The following document represents a summary of the questions and answers presented prior to and during a Deep Dive session undertaken on the VNI West Additional Consultation Report with a technical focus including marketing modelling, cost, policies and procedures.

Category: Market Modelling

SWNSW (N5) - Base Case, Step Change scenario

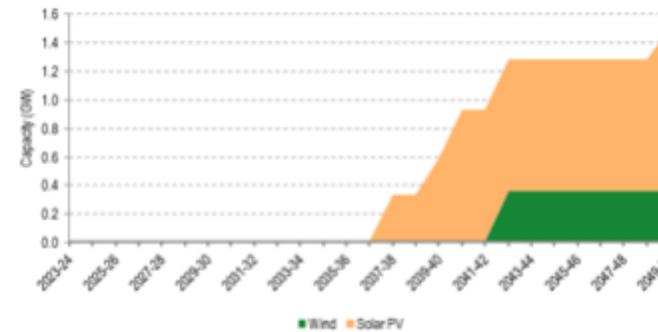
<p>11</p>	<p>Why is only 700MW of the additional 1460MW + 200MW of renewables hosting capacity in the Western Victoria REZ used in the 15 years after WRL completion and only 350MW of the additional 900MW for South-West NSW REZ used in the 6 years after VNI West is completed?</p>	<p>The additional transmission capacity of VNI West allows more efficient use of renewables and enables additional wind and solar build. However, the quantity of wind and solar capacity built in each REZ are model outcomes. The model builds different technologies in the NEM on a least cost basis, considering the costs including capex, VOM, FOM and fuel costs if applicable. For renewables, the quality of resources and expected generation availability (on an hourly basis for multiple weather pattern reference years) as well as the available transmission capacity (and if required the cost of additional transmission capacity) are considered in the modelling.</p> <p>The question is correct in the quoted numbers for the Western Victoria (V3) and South West NSW (N5) REZs (as shown in figures below) and the assertion that this means the increments in transmission capacity associated with VNI West Option 5 are not fully utilised during the quoted periods.</p> <p>Even though REZ transmission increments are not fully utilised immediately after commissioning, Option 5 is assessed as having net benefits of approximately \$1.4 billion dollars. In this assessment of costs against benefits the relative timing of the two is a key influence on net position.</p> <p>Western Victoria (V3) – Base Case, Step Change scenario</p>
